**MONTGOMERY COUNTY HISTORIC PRESERVATION COMMISSION**  
**STAFF REPORT**

<b>Address:</b>	40 Columbia Avenue, Takoma Park	<b>Meeting Date:</b>	2/10/2021
<b>Resource:</b>	Contributing Resource <b>Takoma Park Historic District</b>	<b>Report Date:</b>	2/3/2021
<b>Applicant:</b>	Diana Bradley (Brian McCarthy, Architect)	<b>Public Notice:</b>	1/27/2021
<b>Review:</b>	HAWP	<b>Tax Credit:</b>	No
<b>Case No.:</b>	939478	<b>Staff:</b>	Dan Bruechert
<b>PROPOSAL:</b>	Accessory Building Demolition and Accessory Structure Construction

**STAFF RECOMMENDATION**

Staff recommends the HPC **approve with one (1) condition** the HAWP.

**A200**

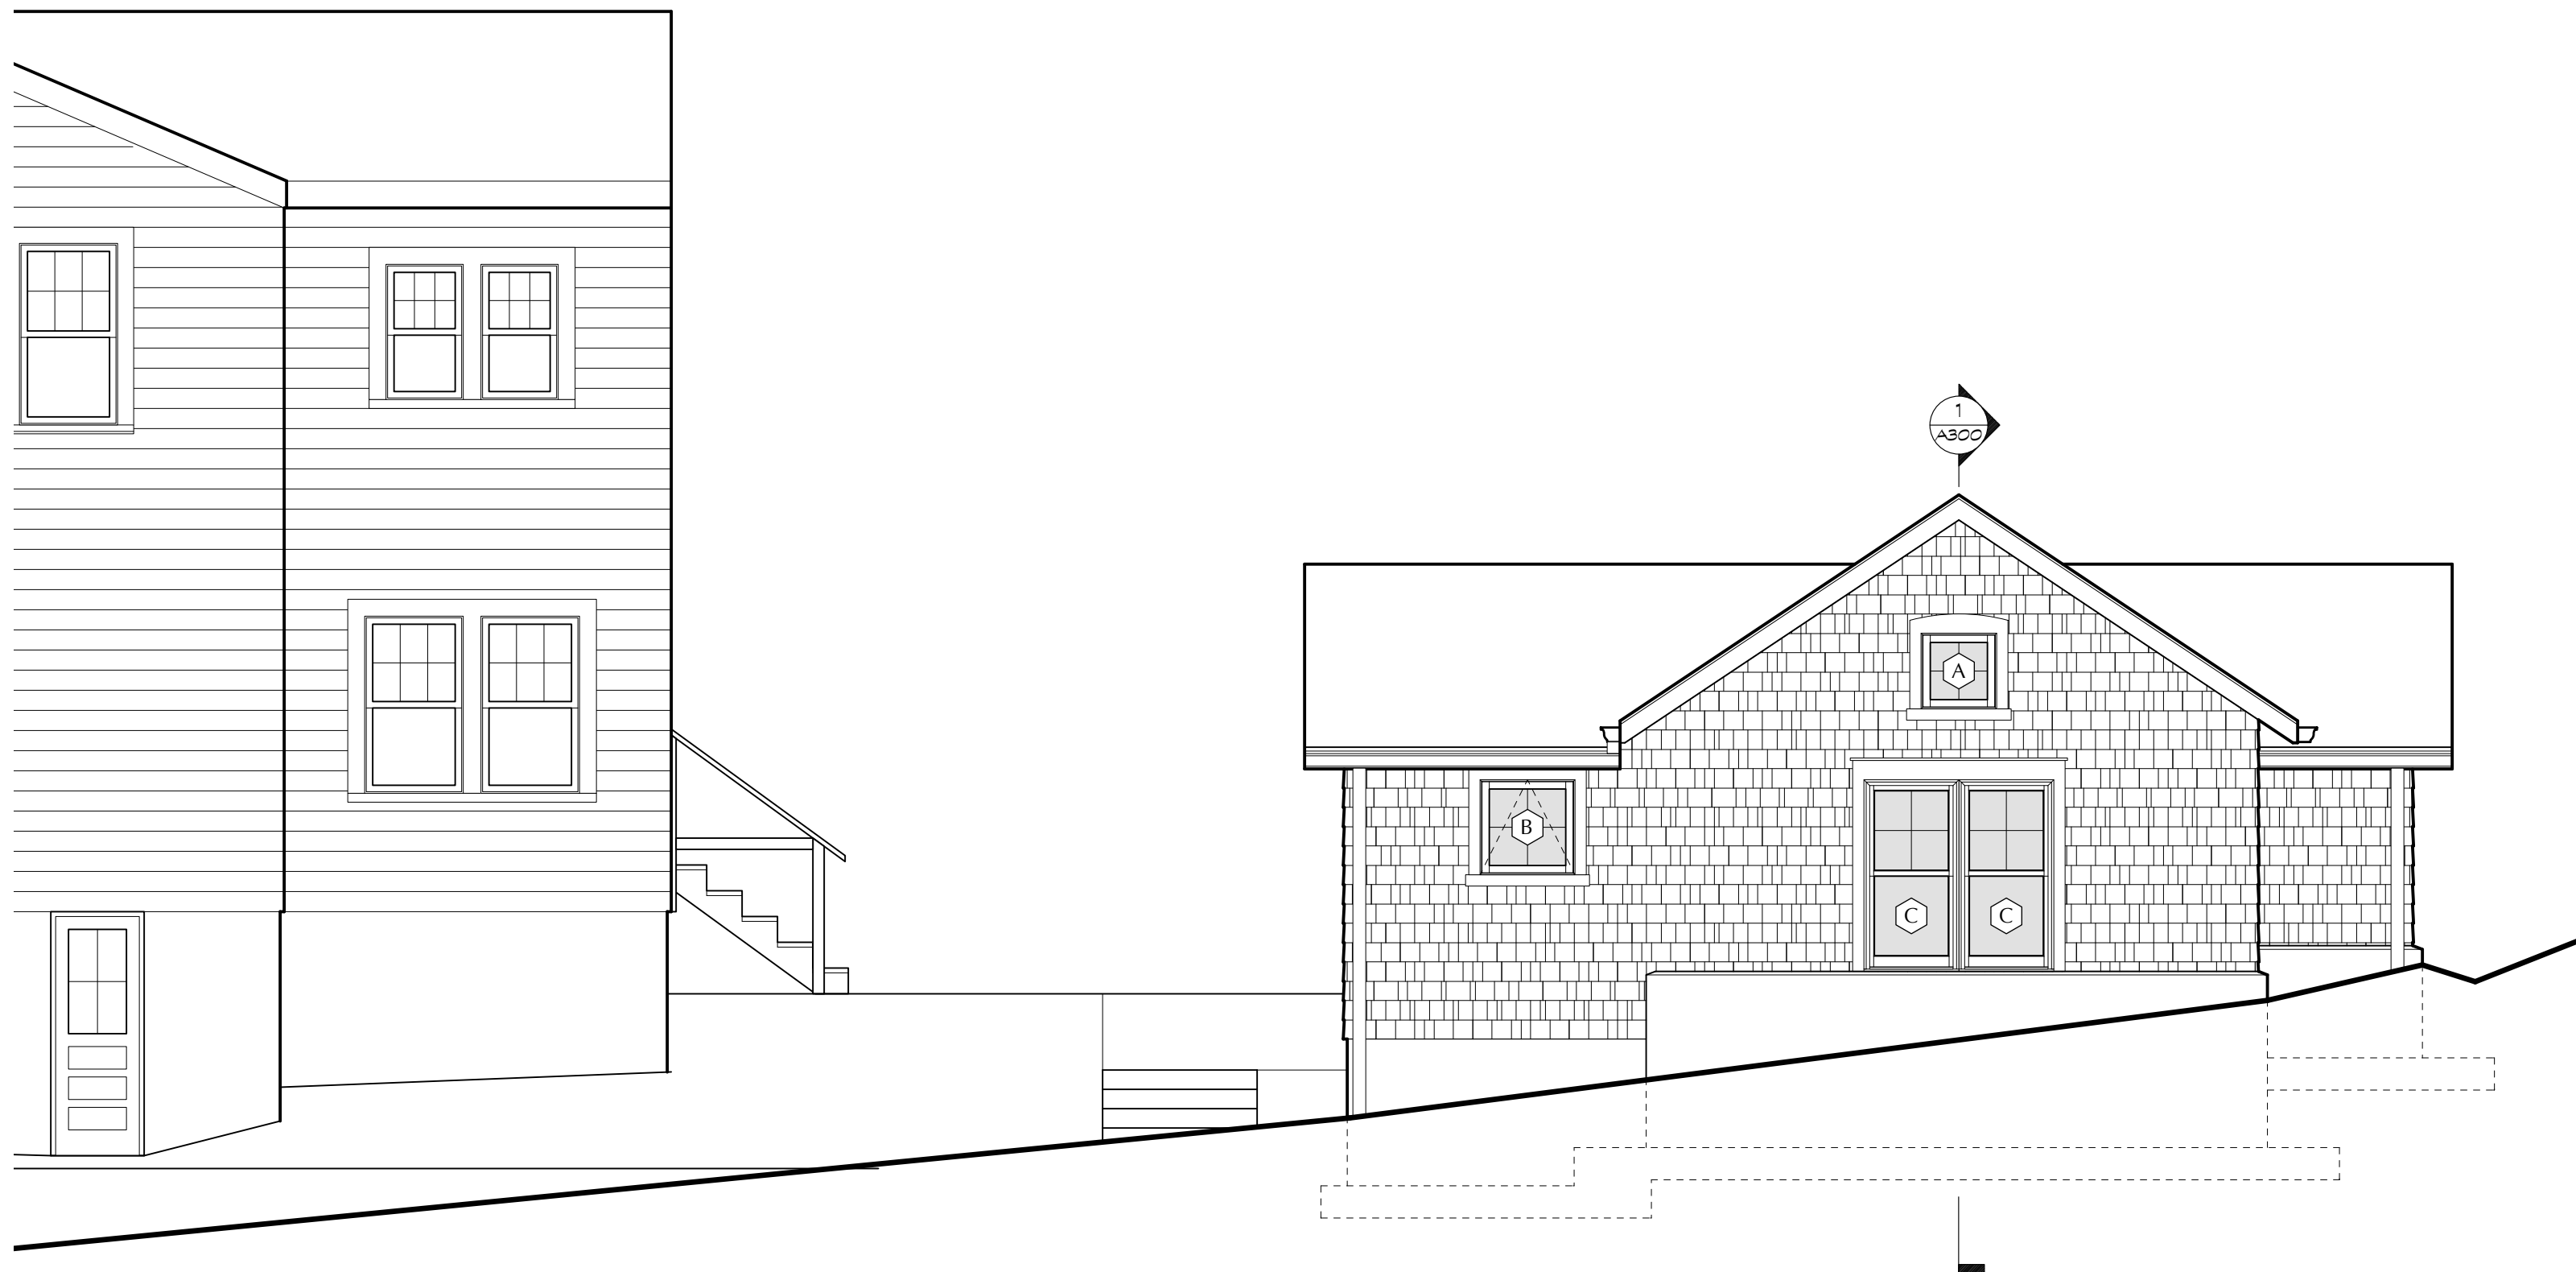
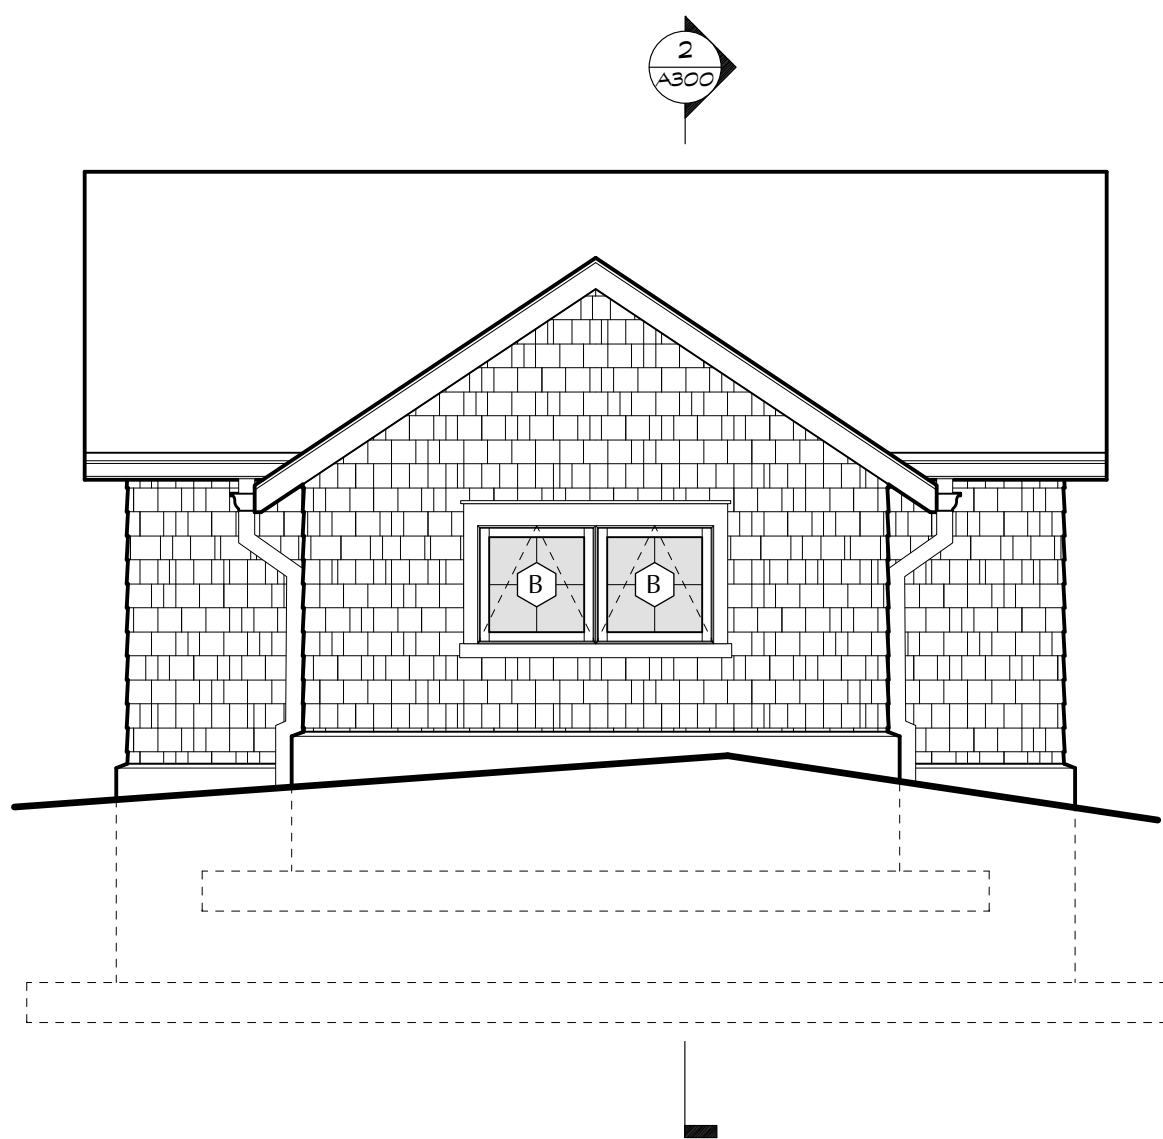
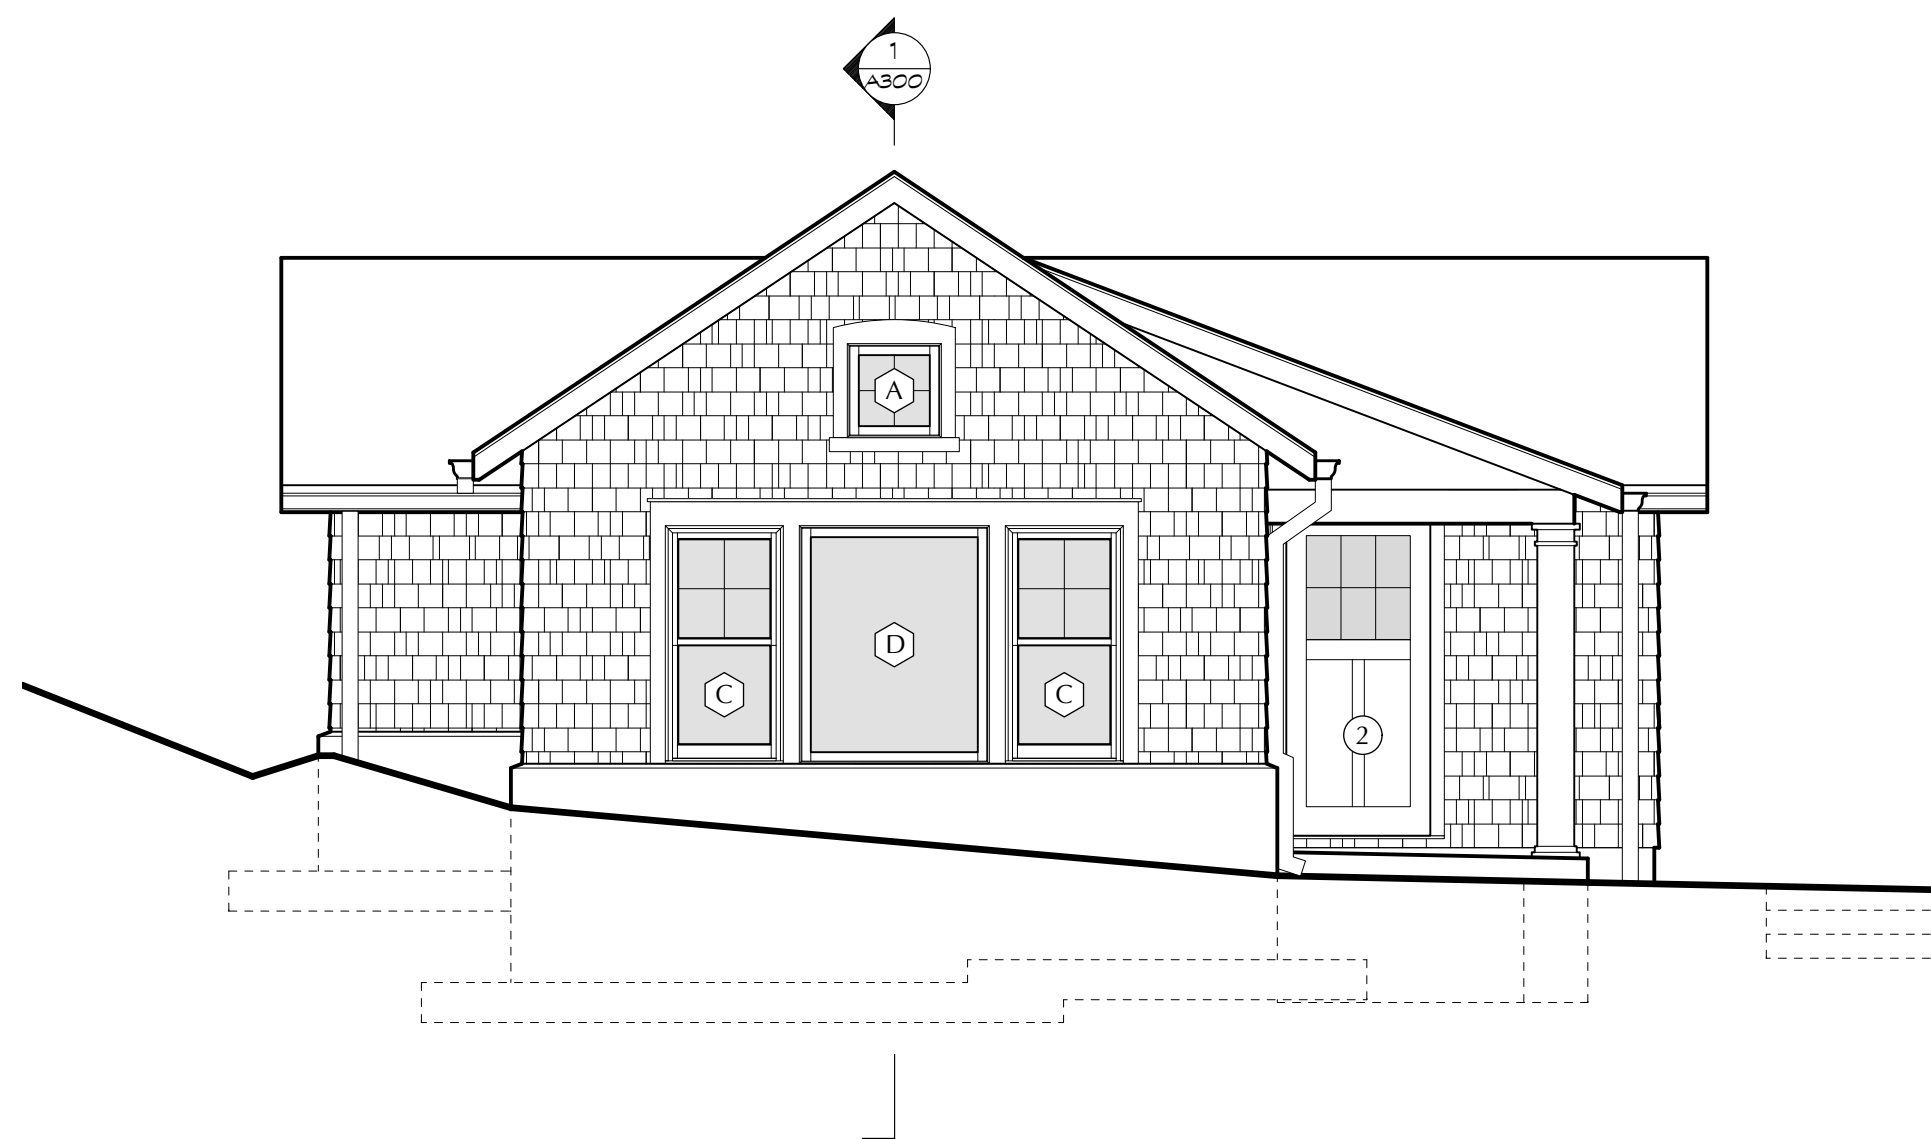
1. Fiber shake siding is acceptable on a new accessory structure. Hardie shake has too narrow of a profile to be compatible and a thicker material needs to be install. Final approval authority of thicker exterior cladding is delegated to Staff for review and approval.

Staff finds that the traditional architectural design of the accessory structure is compatible with the historic resource and early 20<sup>th</sup>-century architecture of the surrounding streetscape. When viewed in elevation, the front gable and preserved garage doors will match the style of the historic house and existing garage. Staff additionally finds that the proposed parged foundation, wood windows and doors, and asphalt shingles are compatible with the historic resource and surrounding district. At the Preliminary Consultation, the HPC found that the fiber cement shakes made by Hardie were too thin to be compatible in the historic setting and that a thicker material needed to be selected. The applicant has not settled on a final exterior fiber cement shingle. Staff recommends the HPC add a condition to the HAWP approval that the exterior cladding needs to be thicker than the ¼” (one-quarter inch) of the Hardie shingles. Final review and approval authority can be delegated to Staff to ensure the condition has been satisfied.
